UNITED STATES PATENT AND TRADEMARK OFFICE

APPLICATION NO.	FILING DATE	FIRST NAMED INVENTOR	ATTORNEY DOCKET NO.	CONFIRMATION NO.
10/779,825	02/17/2004	Gottfried Ungerboeck	BP2431	9140

DETAILED ACTION

FIG. 3

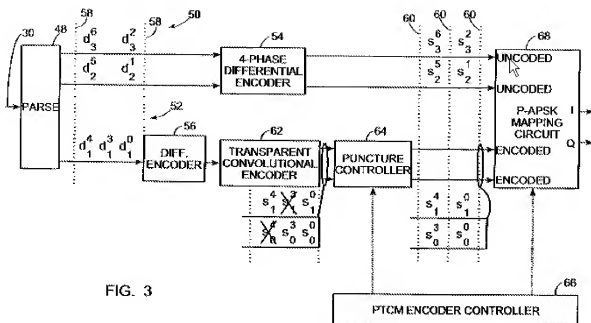
Examiner's response: In figure 3, McCallister et al. clearly illustrates that

encoder 56 produces six encoded bits or symbols (s) in response to the three

information bits processed by the PARSE 30. The output of the encoder 56 is input to

Transparent Convolutional Encoder 62. The encoder 62 produces corresponding

symbol pairs for the data streams in which either both symbols are inverted or neither

symbol is inverted. This clearly shows "rearranging" the order of information bits

coming out of the PARSE 30 from 3 information bits to six information bit which is

performed by encoder 56 and also encoder 56 (see figure 3 below and col 6, lines 39-

67, col 7, lines 1-67.

However, McCallister et al., in the same field of endeavor teaches encoding a plurality of information bits, thereby generating a plurality of encoding bits (52, 56, 62 in figure 3); rearranging an order of the plurality of encoded bits, thereby generating a sequence of discrete-valued modulation symbols (see in figure 3 that the PARSE 30 which produces 3 information bits and the encoder 56 and 62 produces 6 information bit in response to the 3 information bit. The examiner is making his broadest reasonable interpretation that the producing 6 information bits in response to 3 information bits to be rearranging an order of the plurality of encoded bits) (62, 64, 68 in figure 3 and col 7, lines 59-67, col 8, lines 1-65).

rearranging the order of the plurality of encoded bits (see in figure 3 that the PARSE 30

rearranging an order of the plurality of encoded bits), puncturing (64 in figure 3) at least
